Subject ▶ Change on Armature

For Models ▶ 9020L, 9027, 9027L, 9027S, 9029, 9029S, 9037, 9037S, 9039, 9039S (Disc grinders)

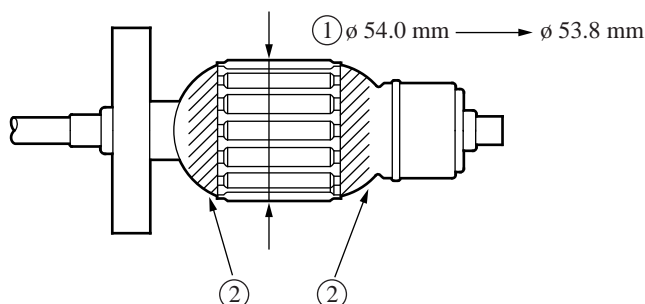
① Outer diameter of the armature core;
changes from ϕ 54.0 mm (2-1/8") to ϕ 53.8 mm
(0.008" shorter than the current armature).

② Addition of white varnish coating
White varnish is coated on the shaded areas of the armature coil.
